# Wellington to Hutt Valley Walking and Cycling Path – Petone to Melling

Preliminary Design Stage

**Safety Audit Report**

**Date:** June 2017

2.2.8. Existing subway barrier

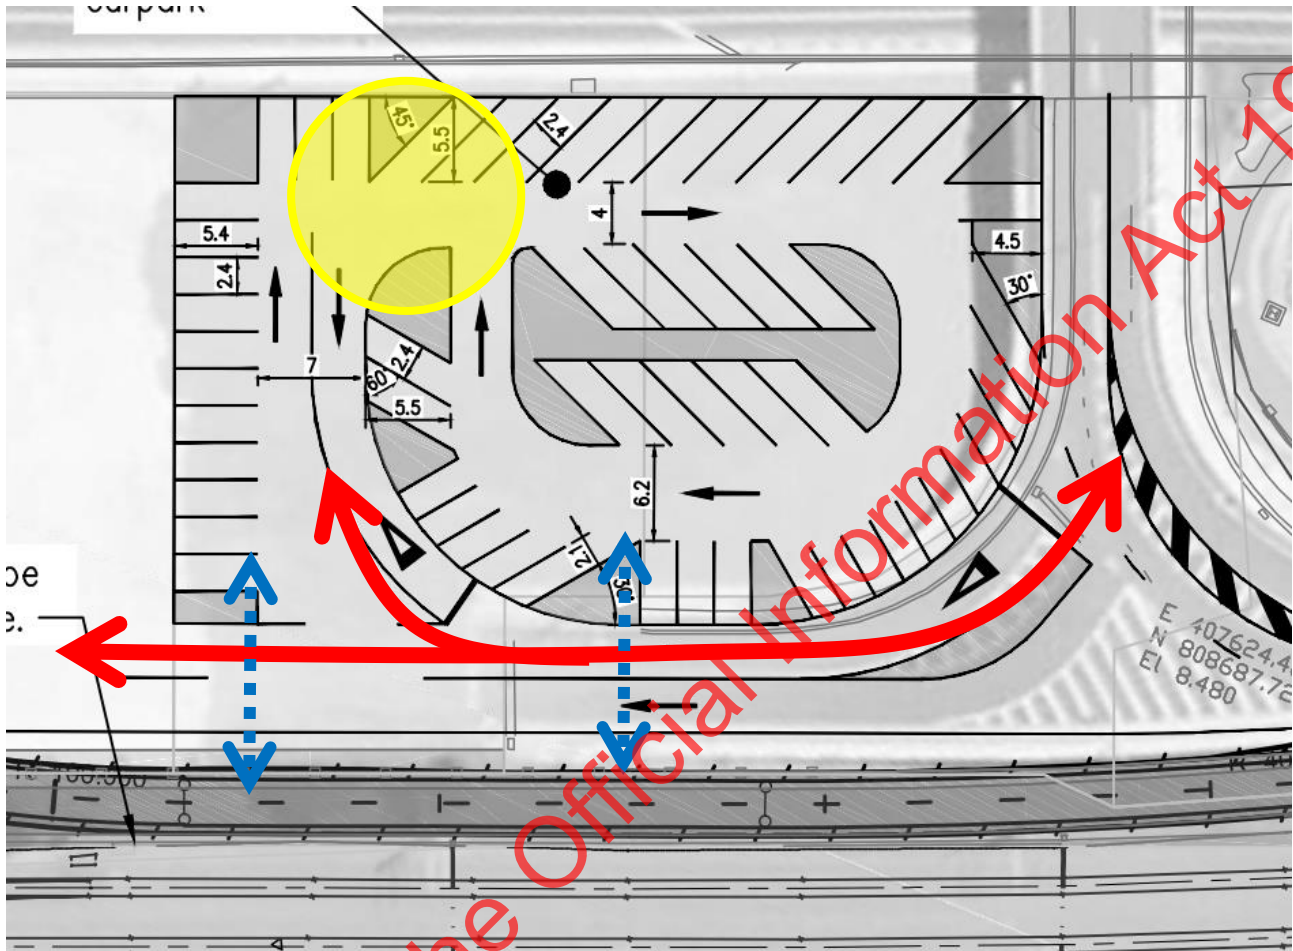
The fence protecting the existing subway will be immediately adjacent to the proposed path. The existing fence is unsuitable as it is climbable and too short to protect cyclists from falling.

Replace existing fence with cycle friendly building code compliant alternative.

<p><b>Frequency Rating:</b> Crashes are likely to be <b>Infrequent</b></p>	<p><b>Severity Rating:</b> Death or serious injury is <b>Very likely</b></p>
<p><b>Designer Response:</b> Will implement safety auditor's recommendations</p>	
<p><b>Safety Engineer:</b> <input type="text" value="Click here to enter text."/></p>	
<p><b>Client Decision:</b> <input type="text" value="Click here to enter text."/></p>	
<p><b>Action Taken:</b> <input type="text" value="Click here to enter text."/></p>

2.2.9. Compensation carpark layout

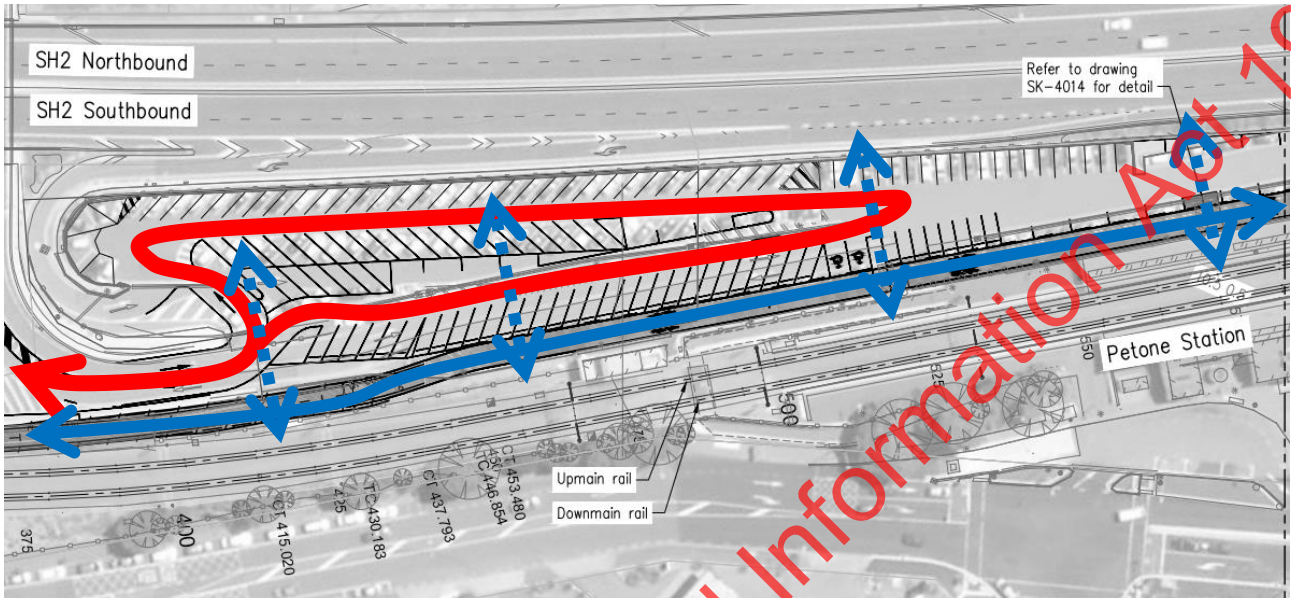
There are no identified safe access routes to the proposed path from carpark which could result in pedestrians unnecessarily walking through the car-park / crossing the access road in areas of poor visibility. Pedestrians may be tempted to walk up the access road to access the station which has no provision for pedestrians and could create conflicts with vehicles.

The area highlighted in yellow below appears too narrow for two-way traffic especially given the u-turn required to exit the carpark.

No information has been provided about the use of wheel stops or solid islands. If physical constraints are not provided, vehicles could appear unexpectedly into the path of other vehicles or pedestrians.

Consider identifying safe walking paths from the carpark and directing pedestrians to the proposed shared path. Review the carpark layout to ensure compliance with AS/NZ 2890 and vehicle tracking is possible. Include wheel stops and / or solid islands to constrain vehicles to the designated routes.

<p><b>Frequency Rating:</b> Crashes are likely to be <b>Occasional</b></p>	<p><b>Severity Rating:</b> Death or serious injury is <b>Unlikely</b></p>
<p><b>Designer Response:</b> Will implement safety auditor's recommendations</p>	
<p><b>Safety Engineer:</b></p>	<p>Click here to enter text.</p>
<p><b>Client Decision:</b></p>	<p>Click here to enter text.</p>
<p><b>Action Taken:</b></p>	<p>Click here to enter text.</p>

2.2.10. Main car-park layout

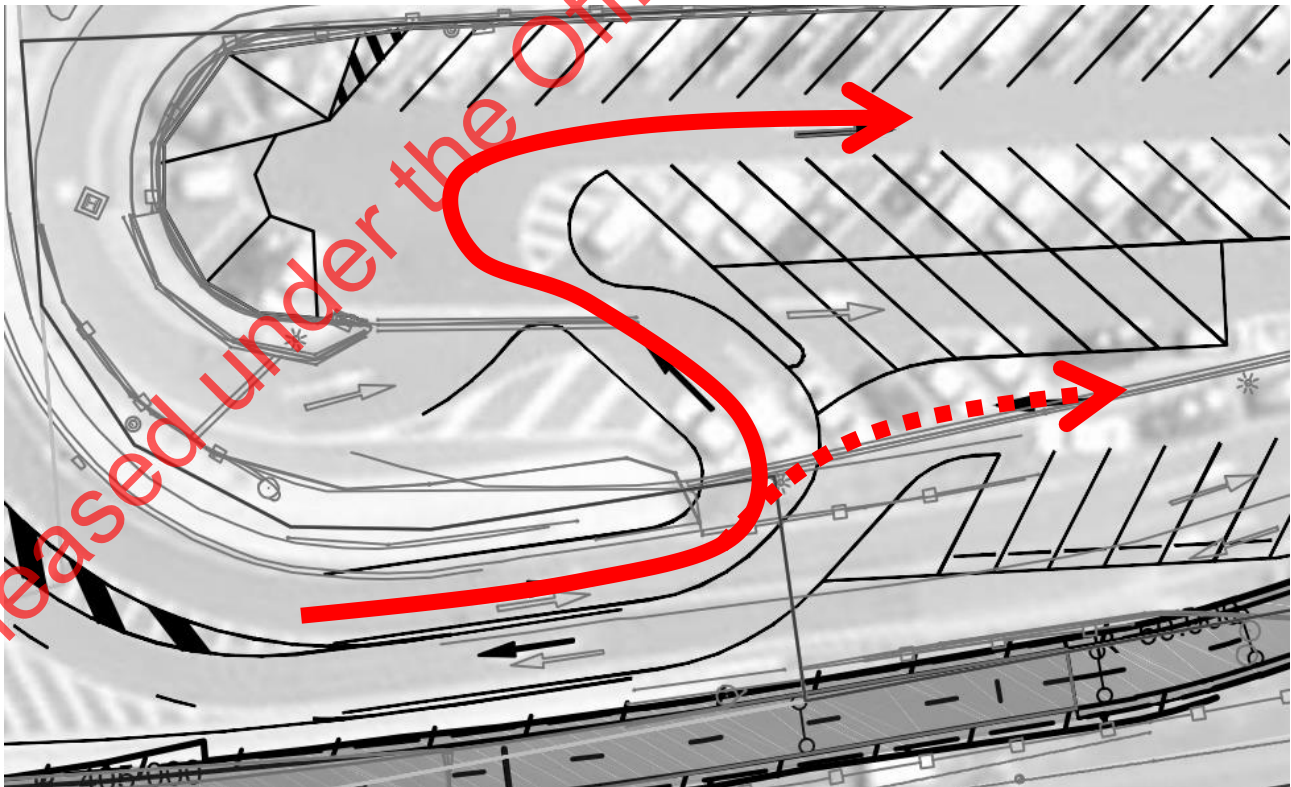
There are no identified safe access routes to the proposed path from carpark which could result in pedestrians unnecessarily walking through the car-park / crossing the access road in areas of poor visibility.

<b>Frequency Rating:</b> Crashes are likely to be <b>Infrequent</b>	<b>Severity Rating:</b> Death or serious injury is <b>Unlikely</b>
<i>Designer Response: Will implement safety auditor's recommendation. With regard to a safe turning area at the north end of the carpark, vehicle drivers are most likely to use the proposed shared path (at the chicane area) as the practical means of finding space to turn. Separation between parallel parks and the shared path will be done by using wheel stops.</i>	
<b>Safety Engineer:</b>	<input type="text" value="Click here to enter text."/>
<b>Client Decision:</b>	<input type="text" value="Click here to enter text."/>
<b>Action Taken:</b>	<input type="text" value="Click here to enter text."/>

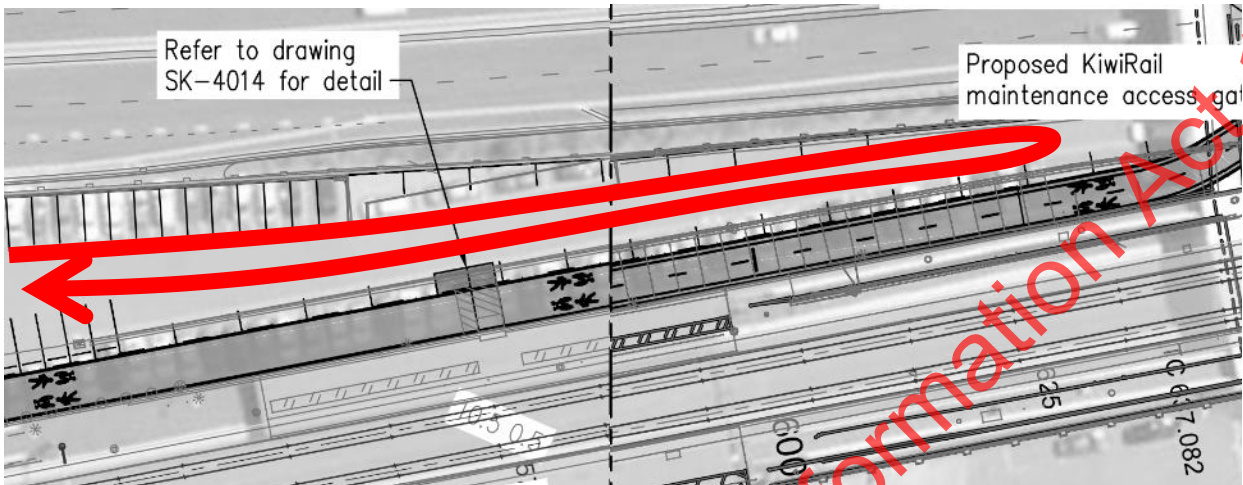
The layout shown below could result in vehicle driving the wrong way through the car-park especially if they see an available park directly in front of them.

No information has been provided about the use of wheel stops or solid islands (except for adjacent to the proposed path). If physical constraints are not provided, vehicles could appear unexpectedly into the path of other vehicles or pedestrians.

The layout at the northern end of the carpark includes no safe turning facility and is likely to result in vehicle reversing a significant distance through the carpark which could lead to conflicts with vehicles and pedestrians.

The section of carpark shown above includes parallel parks directly adjacent to the shared path. Parallel parks create a risk of cycle conflicts with car doors.

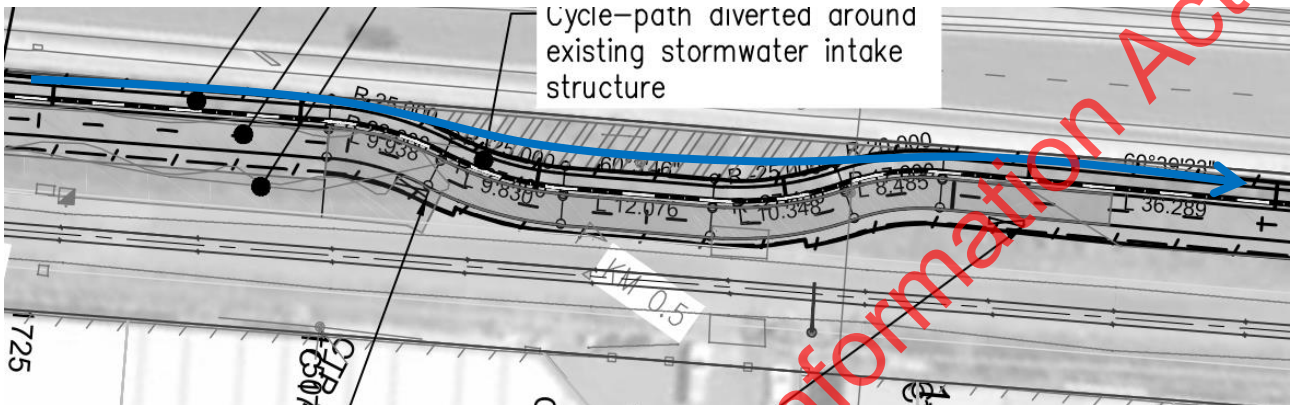
Where cyclists could be riding directly adjacent to the railway security fence or require protection from falling the fence should be replaced with a cycle appropriate barrier.

Hazards on the road side of the path should be protected using a cycle appropriate barrier.

<b>Frequency Rating:</b> <i>Crashes are likely to be</i> <b>Infrequent</b>	<b>Severity Rating:</b> <i>Death or serious injury is</i> <b>Likely</b>
<i>Designer Response: No action required. Similar installations eg Tawa to Porirua along the rail corridor have the same security fence as proposed for P2M, therefore do not agree that this risk warrants specific measures. The stormwater intake will have a cycle friendly banquette installed around the edge to prevent cyclists from falling.</i>	
<b>Safety Engineer:</b>	Click here to enter text.
<b>Client Decision:</b>	Click here to enter text.
<b>Action Taken:</b>	Click here to enter text.

### 2.4.2. Access to cycle only path

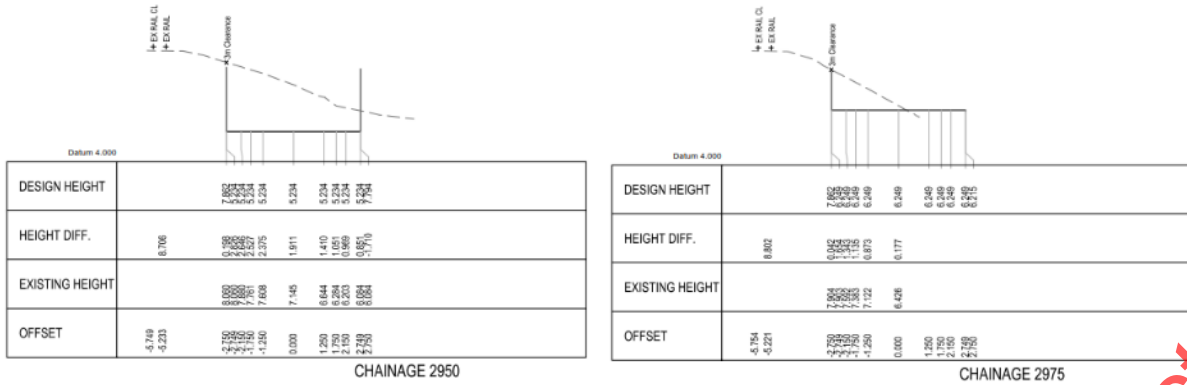
No details are provided on how pedestrians and vehicles are proposed to be restricted from the cycle only path.

Provide regulatory signage / bollards.

<b>Frequency Rating:</b> <i>Crashes are likely to be</i> <b>Infrequent</b>	<b>Severity Rating:</b> <i>Death or serious injury is</i> <b>Unlikely</b>
<b>Designer Response:</b> <i>Signage will be provided defining intended users</i>	
<b>Safety Engineer:</b>	Click here to enter text.

2.4.4. Parliament Street/Bridge Street intersection **Serious**

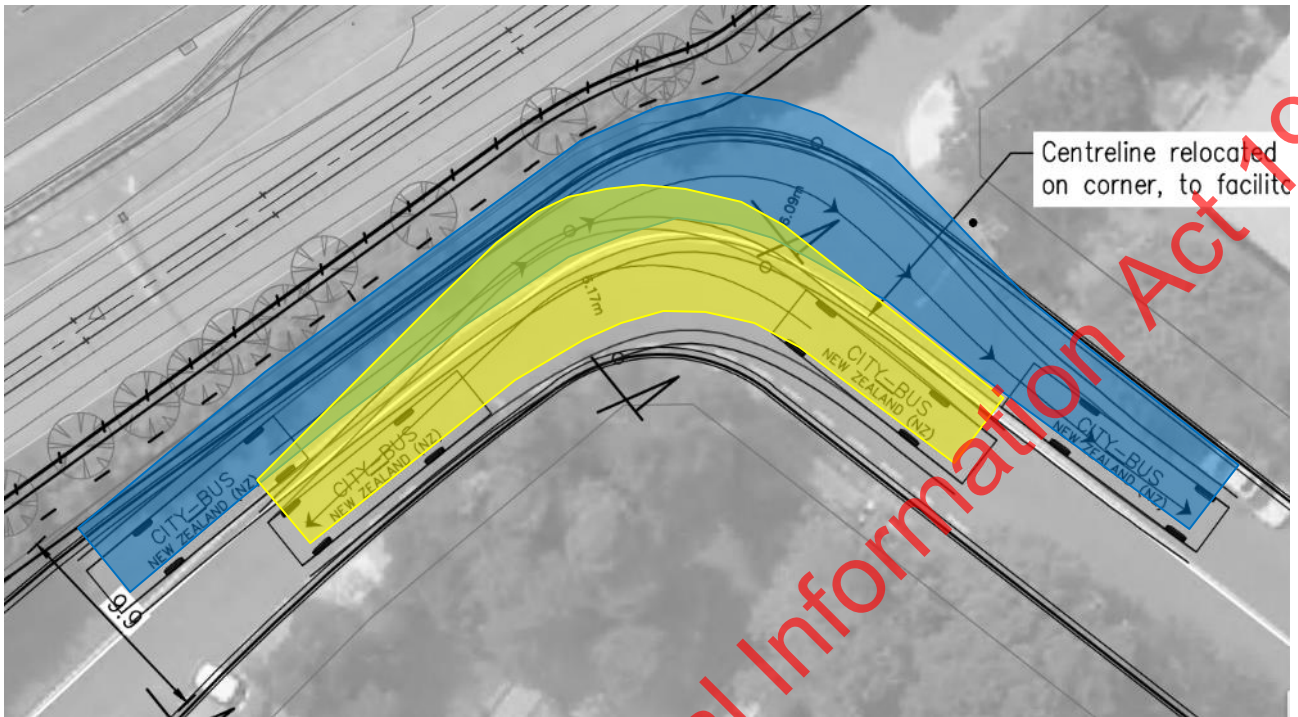
The proposed design narrows the carriageway through this right angle bend by approximately one metre. Observations on site identified that buses track over the centreline through the intersection / curve, this is reinforced by the tracking provided to SAT (shown below).

<b>Frequency Rating:</b> Crashes are likely to be <b>Frequent</b>	<b>Severity Rating:</b> Death or serious injury is <b>Likely</b>
<i>Designer Response: Discussions are underway with KiwiRail to lessen their safety zone to 2.5m as opposed to the standard 3.0m. The angle of the existing kerbline, correlated to the recommendation in 2.4.3 above will keep the kerbline in the same position as existing, thereby the current risk from buses encroaching over the centreline remains as is. Discuss with HCC if acceptable.</i>	
<b>Safety Engineer:</b>	<a href="#">Click here to enter text.</a>
<b>Client Decision:</b>	<a href="#">Click here to enter text.</a>
<b>Action Taken:</b>	<a href="#">Click here to enter text.</a>

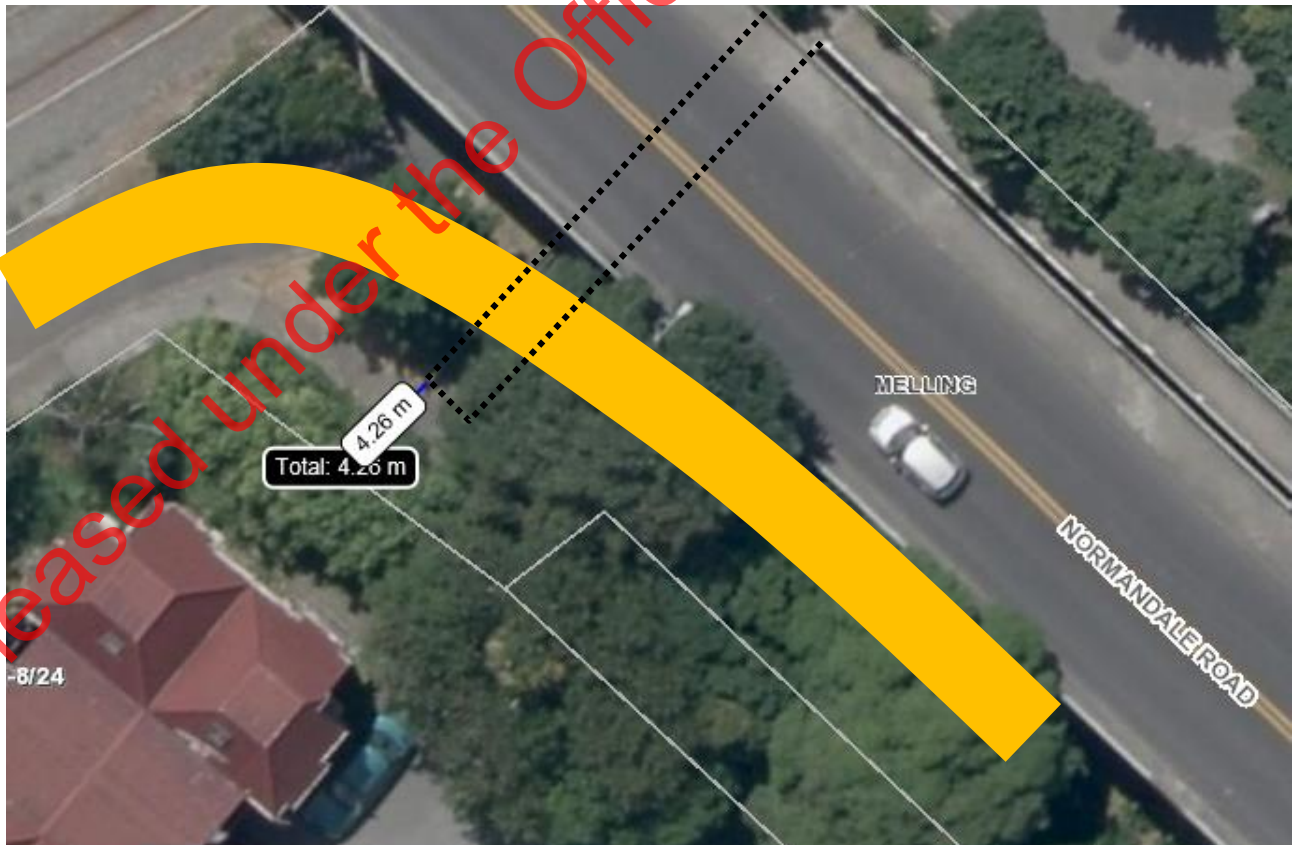
No detail is provided on the proposed treatment of the proposed path along the cul-de-sac. Potential conflicts exist with vehicles (narrow width) and accesses.

Provide appropriate treatment of the space to minimise conflicts with residents vehicles.

<b>Frequency Rating:</b> <i>Crashes are likely to be</i> <b>Infrequent</b>	<b>Severity Rating:</b> <i>Death or serious injury is</i> <b>Unlikely</b>
<b>Designer Response:</b> <i>Cycle markings will be provided on the western side of Parliament street indicating a formal space along with no parking lines. This enables Council to forcibly remove vehicles parked on the area where cyclists are to travel without compromising the existing parking. Pedestrians will use the existing footpath.</i>	
<b>Safety Engineer:</b>	<input type="text" value="Click here to enter text."/>
<b>Client Decision:</b>	<input type="text" value="Click here to enter text."/>
<b>Action Taken:</b>	<input type="text" value="Click here to enter text."/>

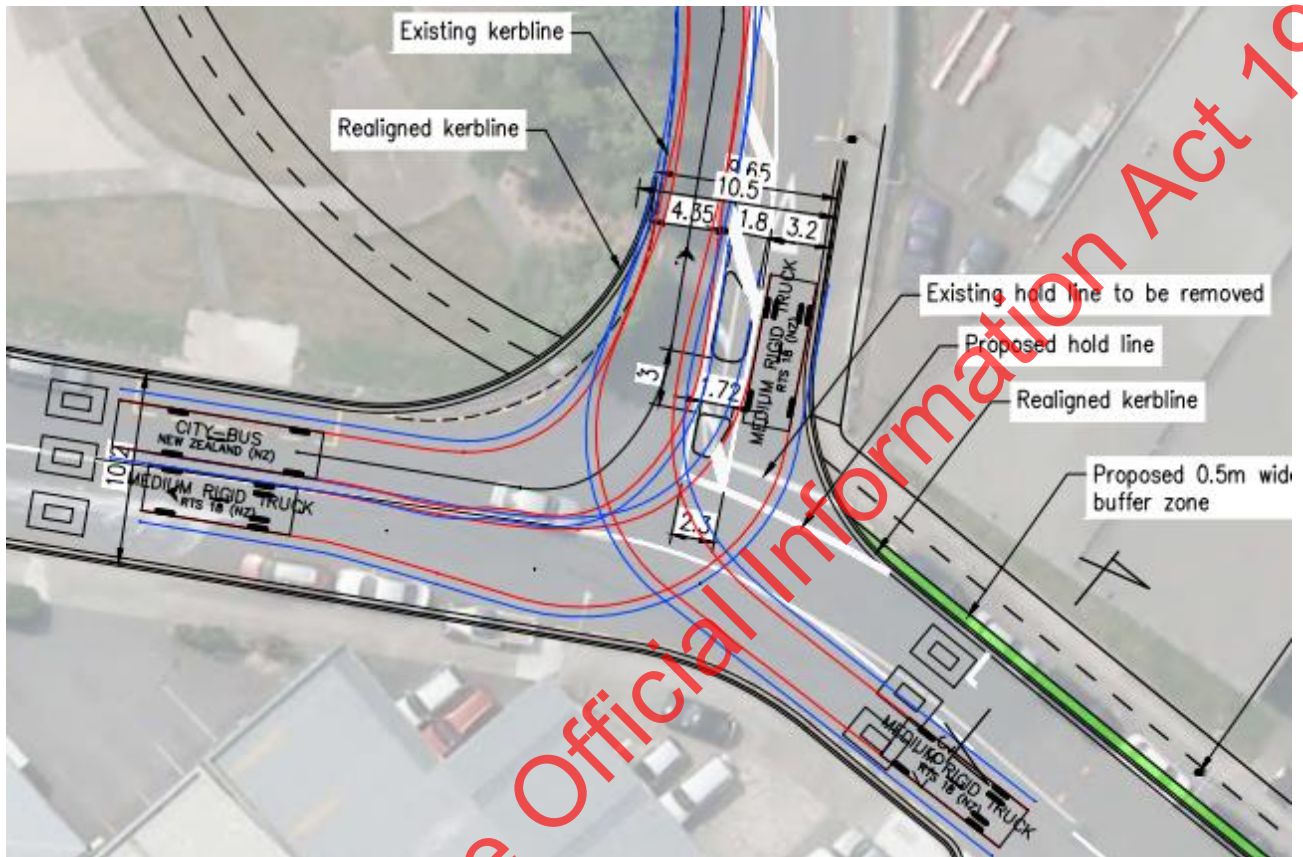
No detail has been provided on the proposed signage for path users, path signage or delineation should indicate that path users need to stop and give-way to vehicles.

Remove vegetation from corner.

Relocate bus stop and remove parking from intersection.

Square up corners to reduce vehicle speeds and reduce crossing distance.

<p><b>Frequency Rating:</b> Crashes are likely to be <b>Frequent</b></p>	<p><b>Severity Rating:</b> Death or serious injury is <b>Likely</b></p>
<p><b>Designer Response:</b> <i>If this option is chosen as the preferred option, then the auditor's recommendations will be adopted</i></p>	
<p><b>Safety Engineer:</b> <a href="#">Click here to enter text.</a></p>	
<p><b>Client Decision:</b> <a href="#">Click here to enter text.</a></p>	
<p><b>Action Taken:</b> <a href="#">Click here to enter text.</a></p>
